SIGNING AND PAVEMENT MARKINGS

HIGHWAY 1 AT MOUNTAIN HIGHWAY INTERCHANGE
MOUNTAIN HIGHWAY - 20 LINE & 80 LINE / E. KEITH RD - 70 LINE
STA. 80+075.000 TO STA. 20+270.000 / STA. 70+250.000 TO STA. 70+552.444

FILE NUMBER	PROJECT NUMBER	REG	DRAWING NUMBER	REV
153CS0851	12573-2016	1	R1-817-606	B

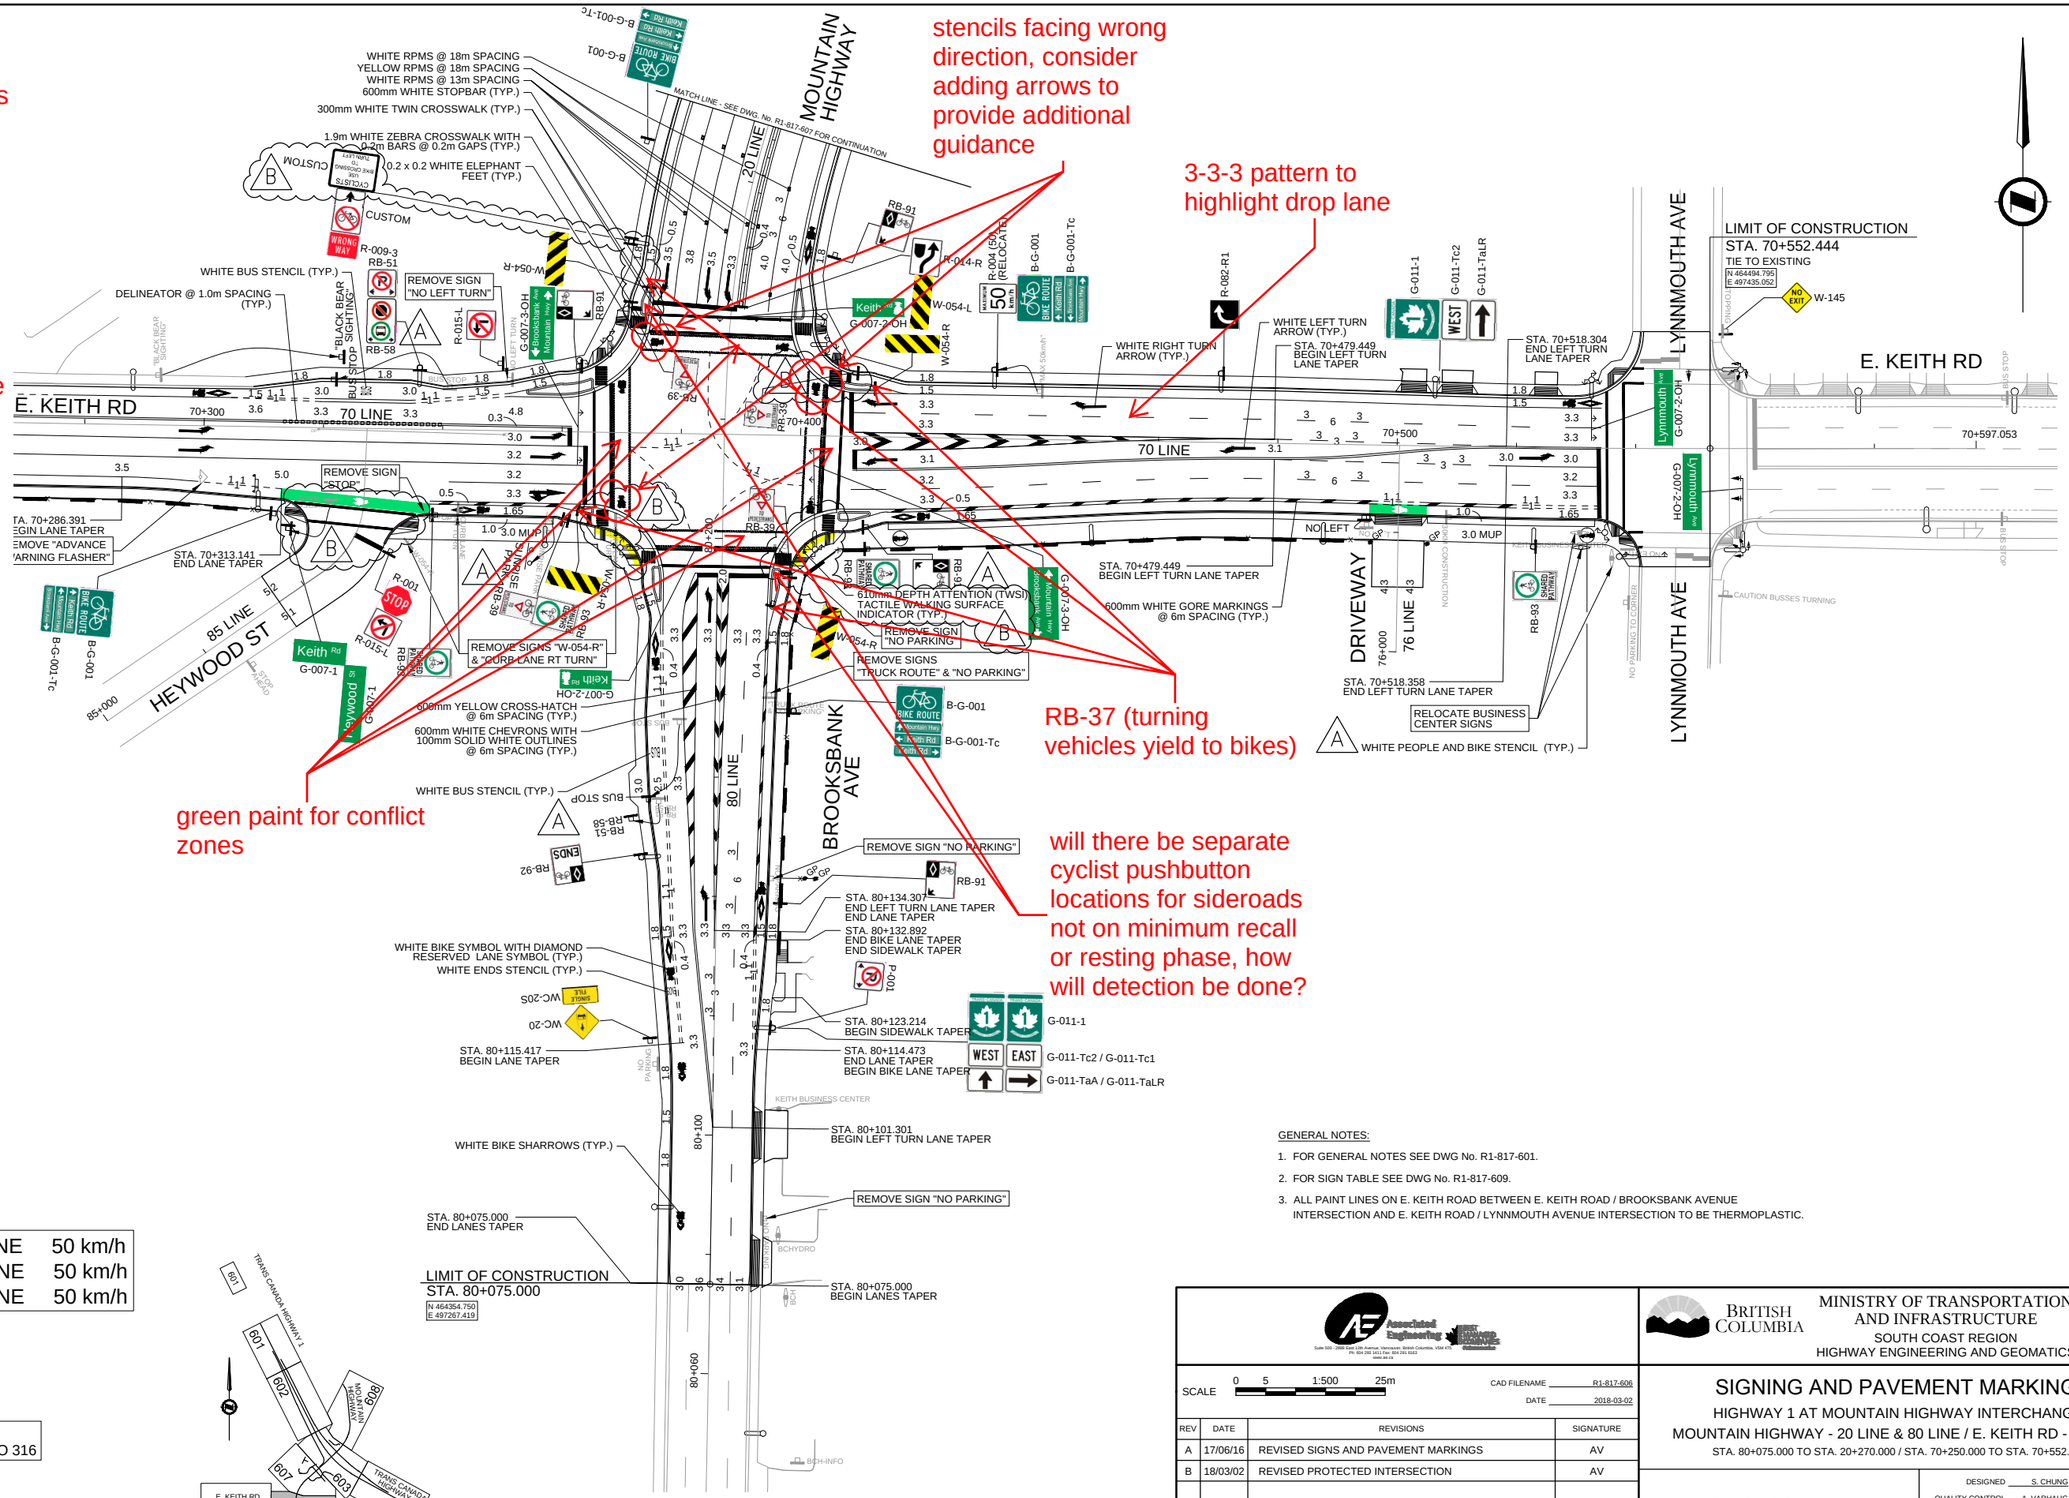
consider right turn on red prohibition due to:
-steep approach grades with high bicycle entry speeds
-potential for rtor vehicles to block wider crosswalk and offset bike lane area while yielding to oncoming traffic
-two-way MUP operation on south side with bikes potentially entering intersection from right side
-opportunity to convert shared lanes to right turn only lanes, incorporate overlap right turn phase with protected left turn phases and mitigate resultant delay

particularly for the NB and EB approaches which conflict with high speed cycling movements

green paint for conflict zones

stencils facing wrong direction, consider adding arrows to provide additional guidance

3-3-3 pattern to highlight drop lane

RB-37 (turning vehicles yield to bikes)

will there be separate cyclist pushbutton locations for sideroads not on minimum recall or resting phase, how will detection be done?
